DETERMINATION OF NON-SIGNIFICANCE

PROPONENT: Brevia Design Review

LOCATION OF PROPOSAL: 16229 Northup Way

FILE NUMBER: 15-111397-LD

LANDSCAPE
PLAN

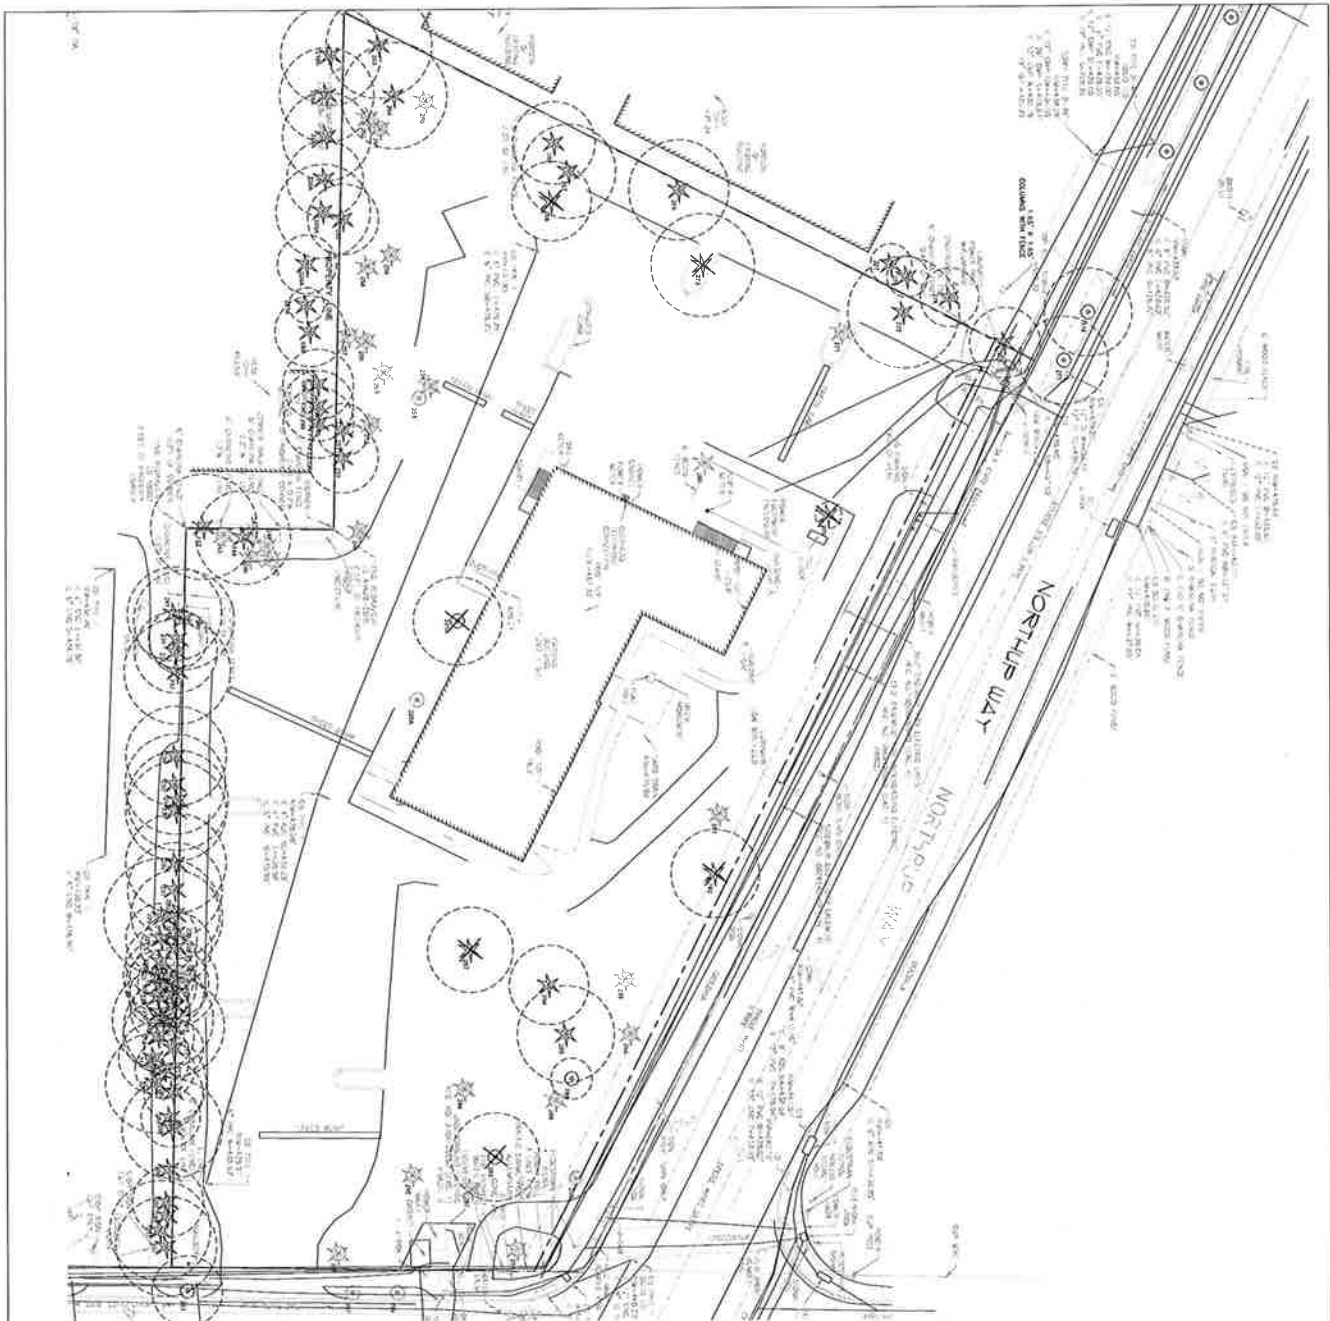
Proper soil preparation will be required. In addition, new plants will require irrigation. The applicant shows irrigation in the landscaping adjacent to Northup Way. (The applicant needs to contact the Parks & Community Services Department regarding feasibility.) Plantings along 164th Avenue NE can hook up to the existing city irrigation system. The plans show that interior plants will be maintained with irrigation until established. The interior plants will not have permanent irrigation.

- a. Contact Tom Kuykendall at the Parks & Community Services Department (425-452-7924 or tkuykendall@bellevuewa.gov) regarding irrigation service along Northup Way.
- b. To ensure that interior plants will thrive, provide a water schedule to show how plants will be cared for during the establishment period (per Sheet L1.0, Note 6) and thereafter.
- c. The applicant shall include a detail for soil preparation on the clearing and grading permit plans, City of Bellevue, Type 2 Soil Preparation, Attachment B.

- (a) Contact Tom Kuykendall at the Parks & Community Services Department (425-452-7924 or tkuykendall@bellevuewa.gov) regarding irrigation service along Northup Way.
- (b) To ensure that interior plants will thrive, provide a water schedule to show how plants will be cared for during the establishment period (per Sheet L1.0, Note 6) and thereafter.
- (c) The applicant shall include a detail for soil preparation on the clearing and grading permit plans, City of Bellevue, Type 2 Soil Preparation, Attachment B.

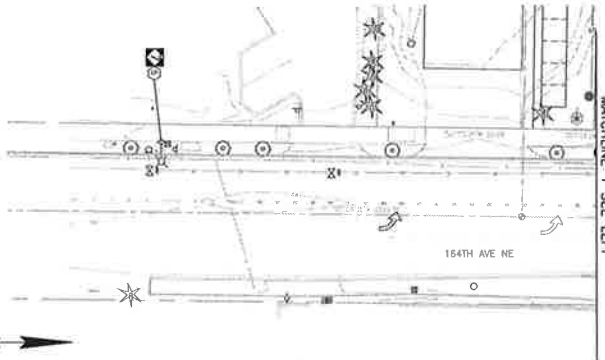
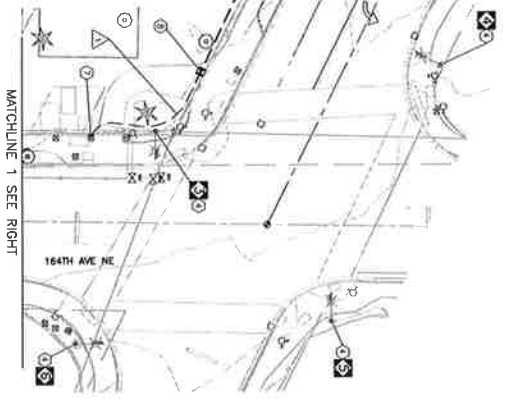
The applicant is removing the latter street light, which is on a wooden pole and replacing it with a 55W LED luminaire on a concrete pole. The proposed location is approximately 30 feet west of the existing location. A combined street tree and street light plan is required for review and approval prior to completion of engineering and landscape plans. The goal is to provide the optimum number of street trees while not compromising the light and safety provided by streetlights. Street trees and streetlights must be shown on the same plan sheet with the proper separation (generally 25 feet apart) and the proper spacing from driveways (ten feet from Point A in standard drawing DEV-7F or equivalent).
